Product Upgrade Bulletin 170615REV

PRODUCT(S) AFFECTED:
Fleetwood Storm
Holiday Rambler
Vacationer XE

MODEL(S) AFFECTED:
32A, 34 S
manufactured
May 17, 2016
through
March 24, 2017

SUBJECT:
Installing
attachment
brackets for sofa
overhead cabinet

Figure 3

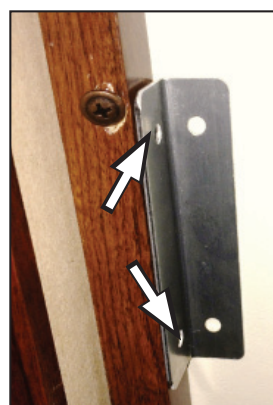
1. Park the motorhome on dry, level pavement with adequate clearance to extend the living room slide-out. Place the transmission in Park and set the parking brake. Chock the wheels to prevent movement.
2. Level the unit using the leveler touchpad.
3. With the engine running, extend the living room slideout.
4. Open the sofa overhead cabinet doors to gain access to the horizontal pine cleat that secures the cabinet face to the ceiling. See Figures 1 & 2.
5. Position a bracket against the horizontal pine cleat and the ceiling. Using the holes in the bracket as a guide, mark the locations for two holes in the pine cleat. See Figure 3.

6. Carefully pre-drill 1/16" x 3/4" deep pilot holes in the cleat. Use new #6 x 5/8" sheetmetal screws to secure the angle bracket to the pine cleat.
